DRAINAGE AND TRANSPORTATION INFORMATION SHEET (REV 6/2018)

Project Title: NM Sol **Building Permit #:** _____ **Hydrology File #:** _____
DRB#: _____ **EPC#:** _____ **Work Order#:** _____
Legal Description: Lot 2-B, Tract S-1, Atrisco Business Park, Unit 2, City of Albuquerque, Bernalillo County, NM
City Address: 7401 Los Volcanes NW

Re: NM Sol/ Phase 1 Tenant Addition
7402 Los Volcanes Rd. NW
Traffic Circulation Layout
Architect's Stamp 03-28-23 (J10-D027)

The following are our responses to your comments on the above TCL.

5'-7"

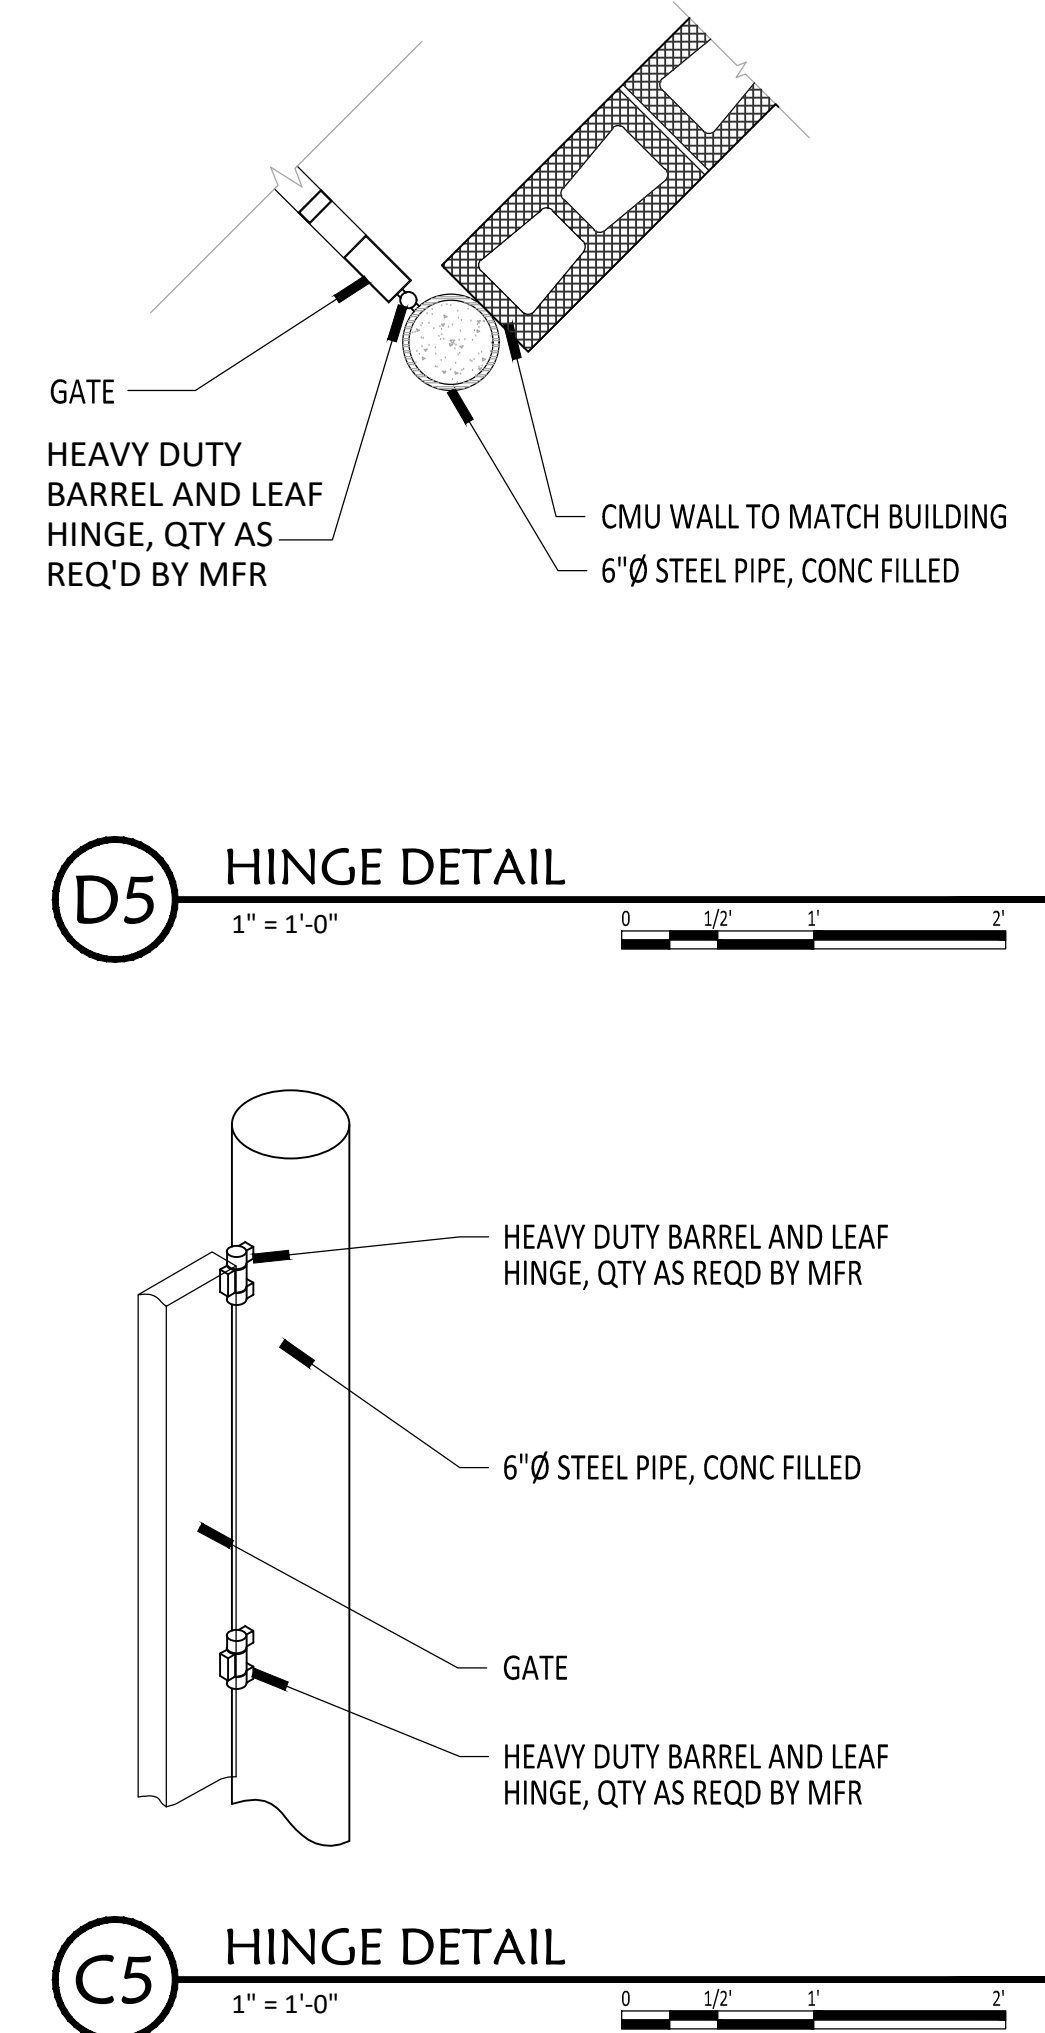
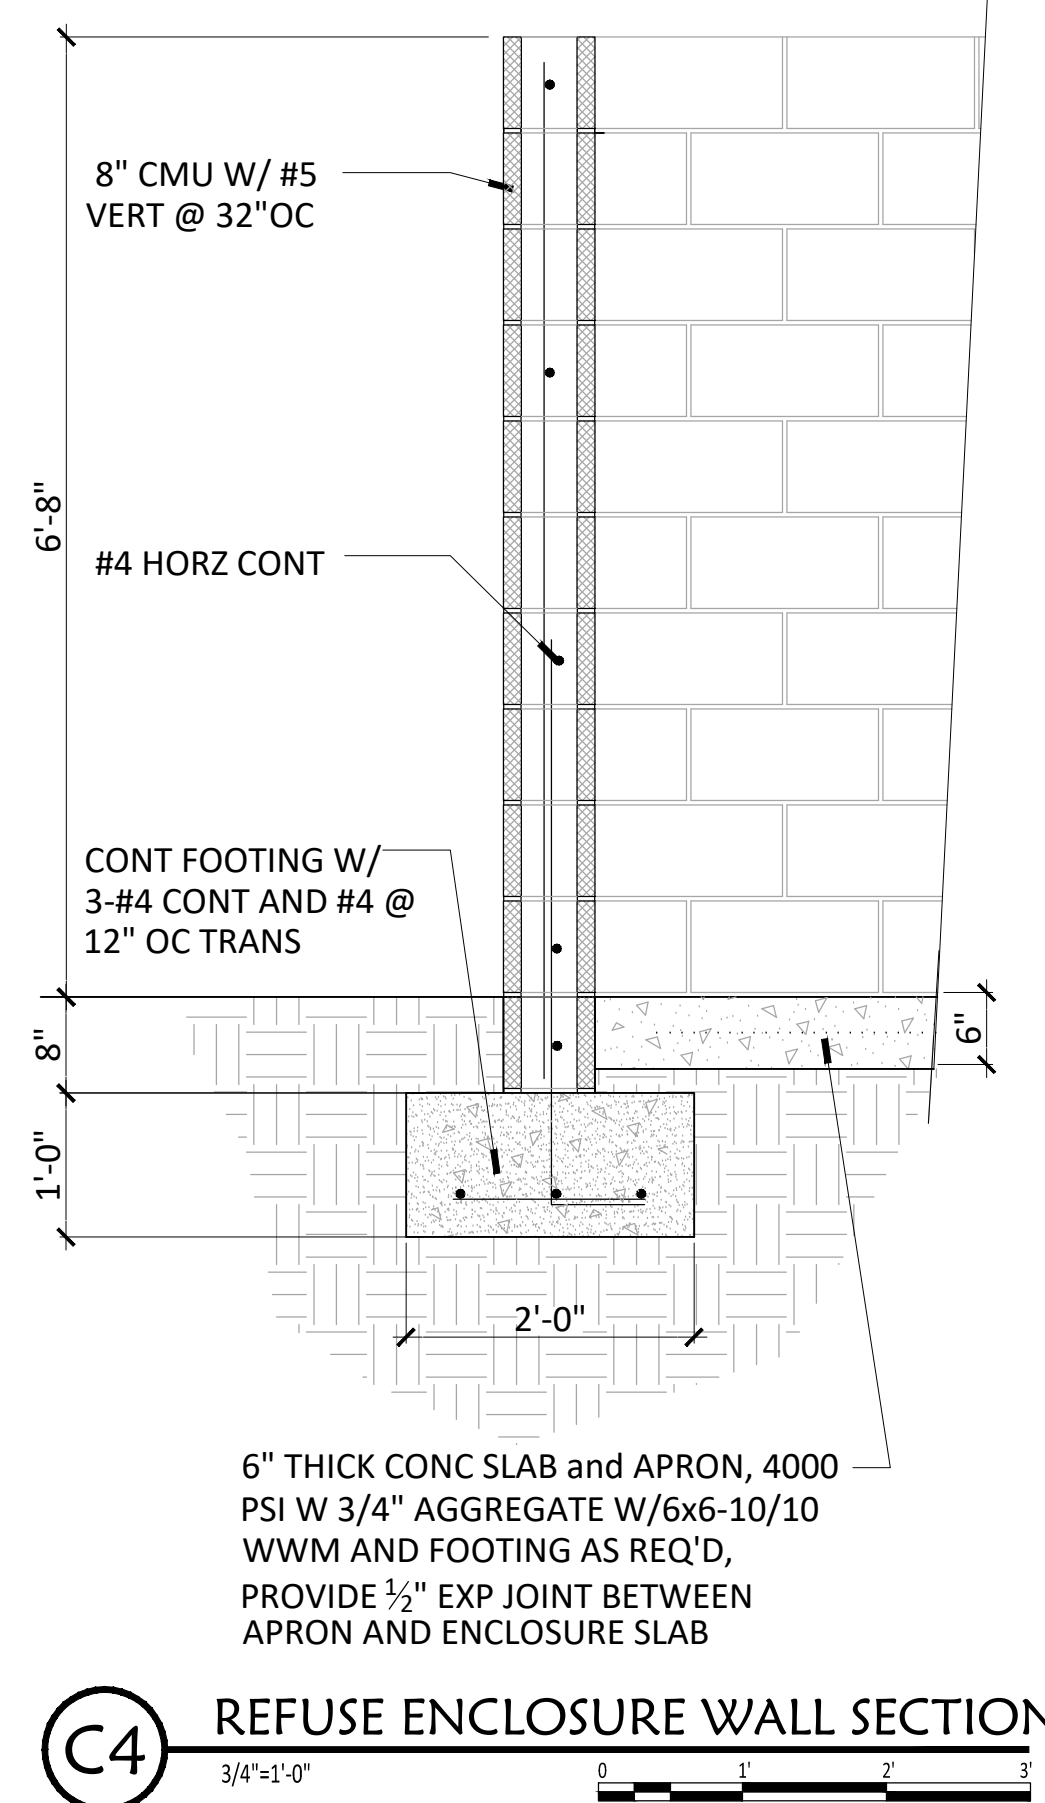
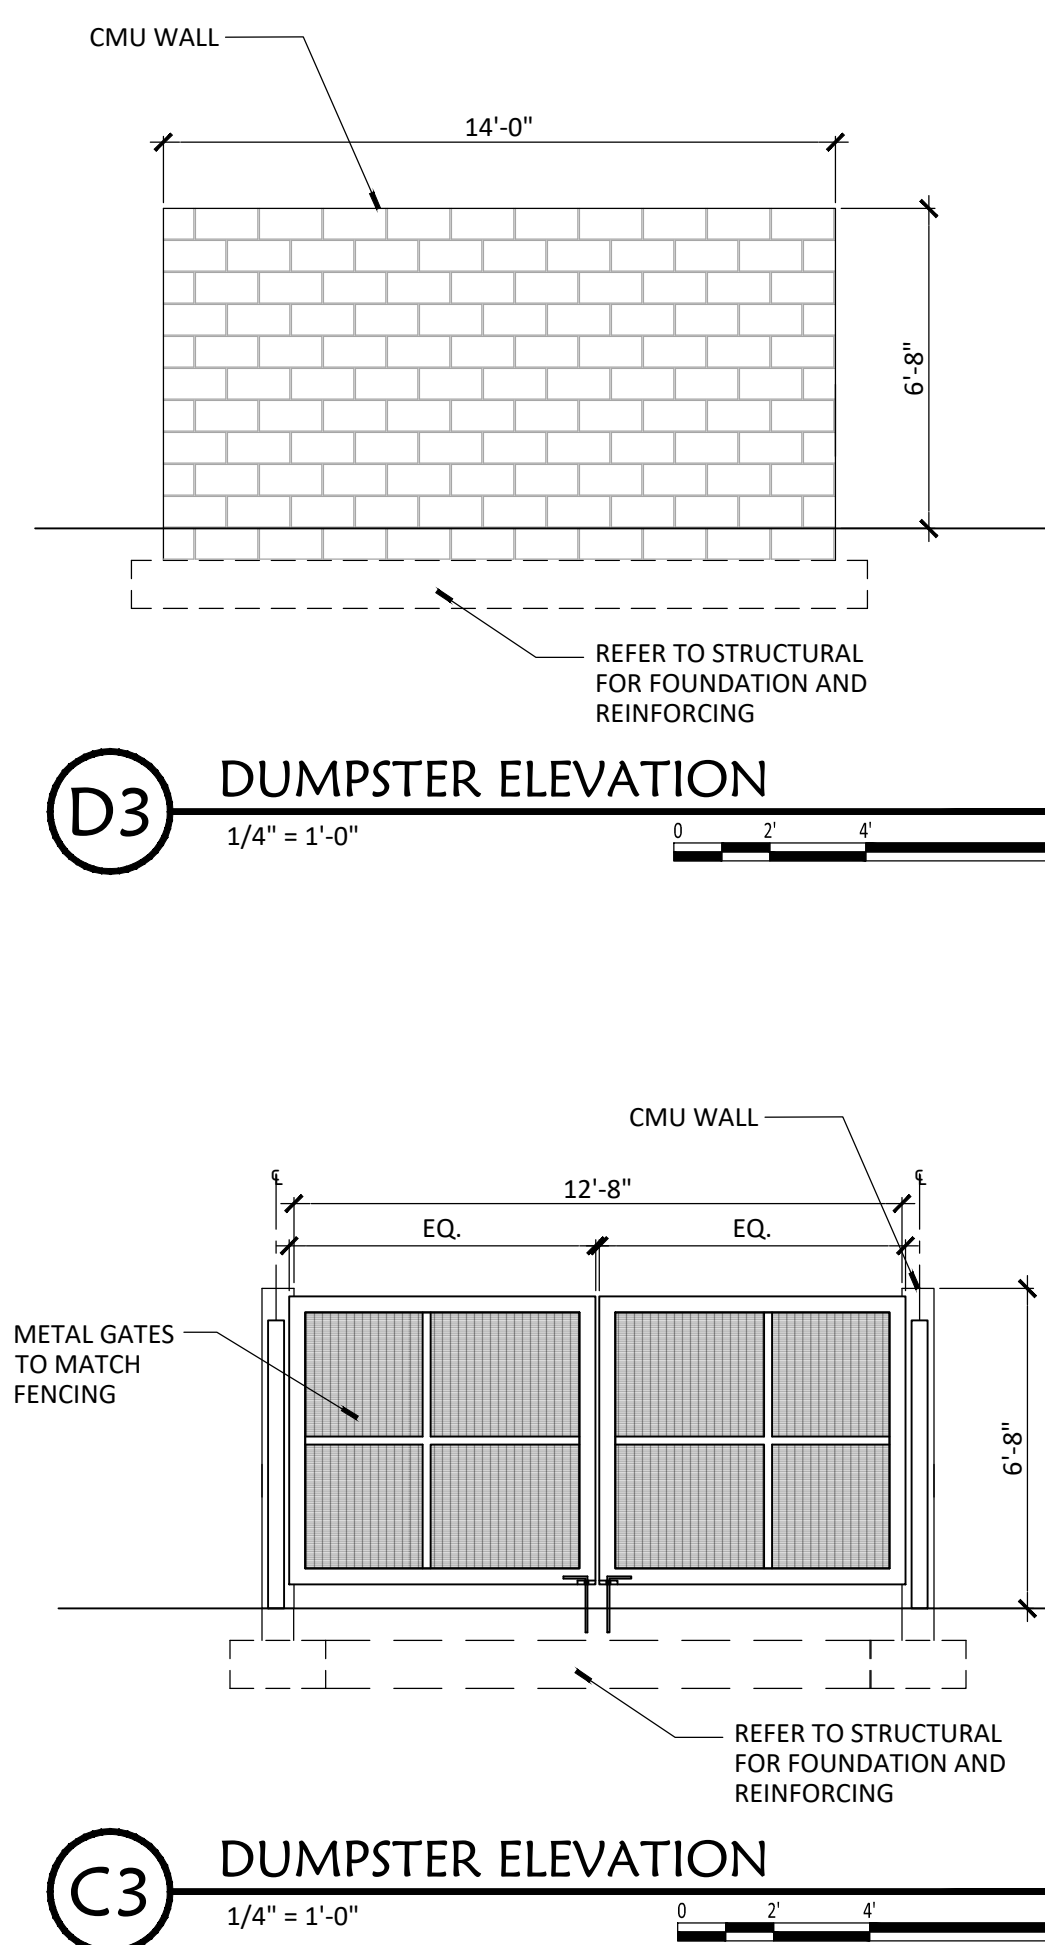
- a. Review AS101 and AS102
6. Per the IDO, a 6 ft. wide ADA accessible pedestrian pathway is required from the public sidewalk to the building entrances. Please clearly show this pathway and provide details.
 - a. Pathway updated, see AS101
7. Per DPM, a 6 ft. wide ADA accessible pedestrian pathway is required from the ADA parking stall access aisles to the building entrances. Please clearly show this pathway and provide details.

- a. Access shown, refer to AS101, AS102
- 8. ADA accessible pedestrian pathway should not be placed behind parking space or adjacent to a vehicular way. Vehicle and pedestrian/wheel chair conflicts should be avoided as much as possible.

- a. Refer to AS102
- 9. Curbing should be installed to delineate landscape, parking, and pedestrian ways and identify points of access. Please call out detail and location of barrier curb.
